PlanGrid Task Report - Oct 9, 2024

L05222_Broadview FSU (IL)

3300 Broadview Village Square, Riverside, Illinois

IMG_1020

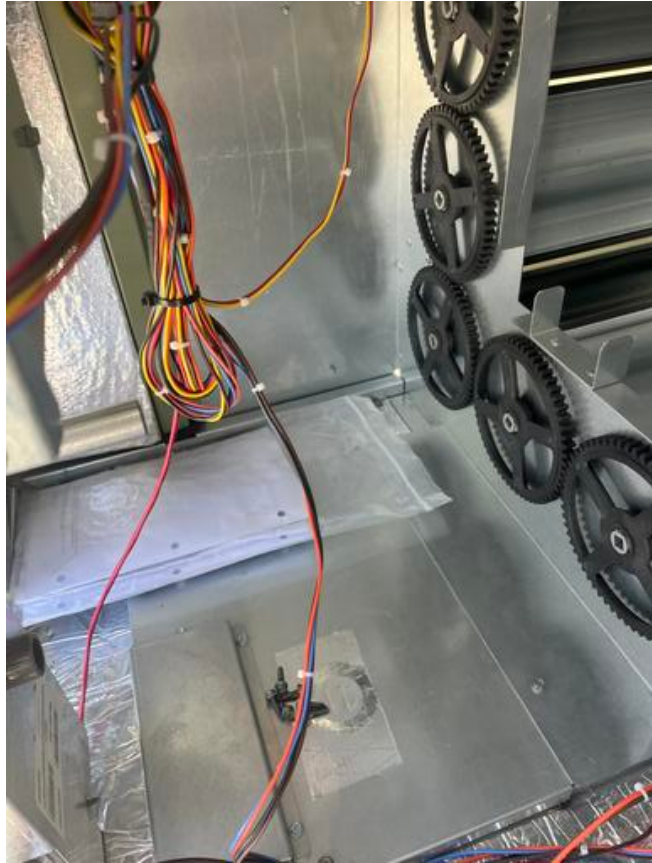
Request confirmation of proper smoke detector sampling tube configuration/installation. AC-1 does not have tube installed. AC-2 has tube installed to detector and routed to return. AC-3 has tube in mixed air compartment but it is not connected to sampling tube.

#575 [UNIT 999][NEW] AC-3 economizer plug backwards from factory

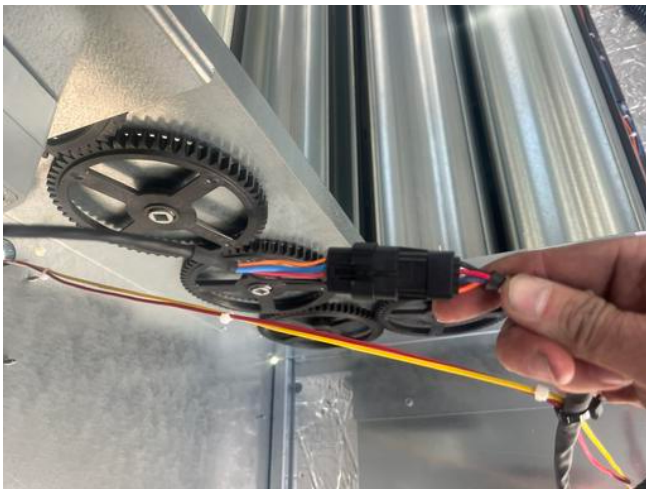
Economizer plug wired backward from factory. Corrected by NTAB. 25% open was 75% open.

Plug cannot be fully secured when rotated to correct orientation.

Recommend plug is secured

#572 [UNIT 999][[NEW] (MISC) AC-3 : Return Humidity Sensor Not Installed

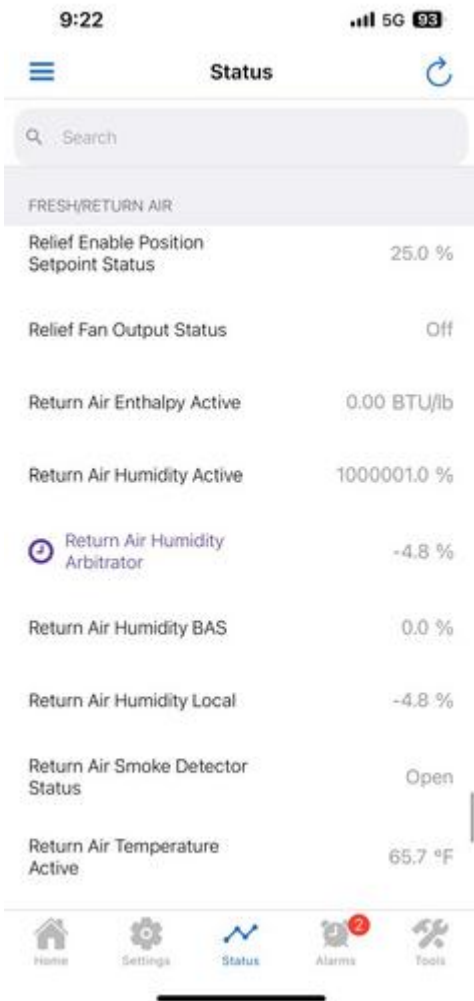
AC-3 is alarmed and does not appear to have a return humidity sensor installed. Recommend TRANE is consulted. This has occurred at multiple locations.
